COMPREHENSIVE PIPELINE INSPECTION REPORT

Project Name:	Mountain Valley Pipeline	Inspector:	Matt Grant
Inspection Date:	Tuesday, January 15, 2019		
Spread: Franklin County MP269 St#14235-14245 MP270 St#14274+39 MP276 St#14587	Spread I	Weather (Wet/Dry/Rain):	Wet

REQUEST FOR CORRECTIVE ACTION

Fig. 1 Between St#14235+00 and St#1428 is not adequately stabilized.

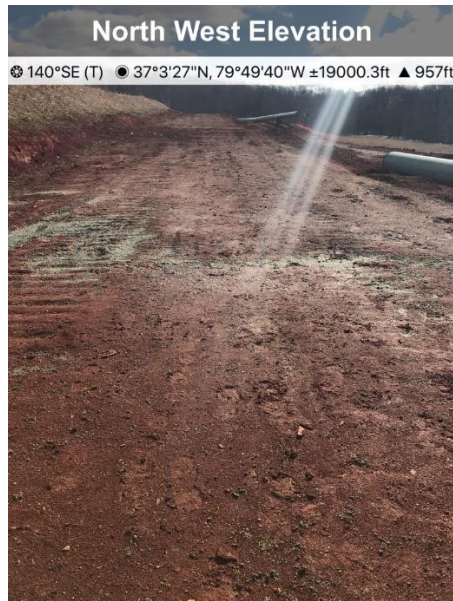
Location or Checklist #	Regulatory Citation/Legal requirement ¹	Observation/Recommended Corrective Action
11	(Va. Code §62.1-44.15:31) (MVP Standards & Specifications for VA, p. 1) (9VAC25-870-54.B) (9VAC 25-840-40.1)	Observation: Between St#14235+00 and St#1428 is not adequately stabilized. <u>Recommended Corrective Action:</u> Stabilize areas per the approved plan and annual standard and spec.
18	(Va. Code §62.1-44.15:31) (MVP Standards & Specifications for VA, p. 1) (9VAC 25-840-40.8)	Observation: Cut slope of two-tone area between St#14236 and St#14245 lacks adequate stabilization. <u>Recommended Corrective Action:</u> Stabilize areas per the approved plan and annual standard and spec.

Fig. 2 Cut slope of two-tone area between St#14236 and St#14245 lacks adequate stabilization

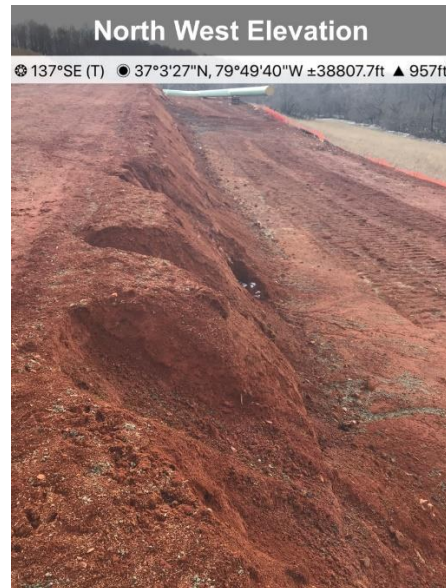
14	Have sediment trapping facilities been constructed as the first step in land disturbance activities? (Va. Code §62.1-44.15:31) (MVP Standards & Specifications for VA, p. 1) (9VAC 25-840-40.4).	☒	☐	☐	
15	Have earthen structures been stabilized immediately after installation? (Va. Code §62.1-44.15:31) (MVP Standards & Specifications for VA, p. 1) (9VAC 25-840-40.5).	☒	☐	☐	
16	Are sediment traps and basins installed in accordance with MS-6 and the approved plan? (Va. Code §62.1-44.15:31) (MVP Standards & Specifications for VA, p. 1) (9VAC 25-840-40.6).	☒	☐	☐	
17	Are finished cut and fill slopes adequately stabilized to prevent or correct excessive erosion? (Va. Code §62.1-44.15:31) (MVP Standards & Specifications for VA, p. 1) (9VAC 25-840-40.7).	☒	☐	☐	
18	Is concentrated runoff flowing down cut or fill slopes contained in an adequate permanent or temporary structure? (Va. Code §62.1-44.15:31) (MVP Standards & Specifications for VA, p. 1) (9VAC 25-840-40.8).	☐	☒	☐	Cut slope of two-tone area between St#14236 and St#14245 lacks adequate stabilization.
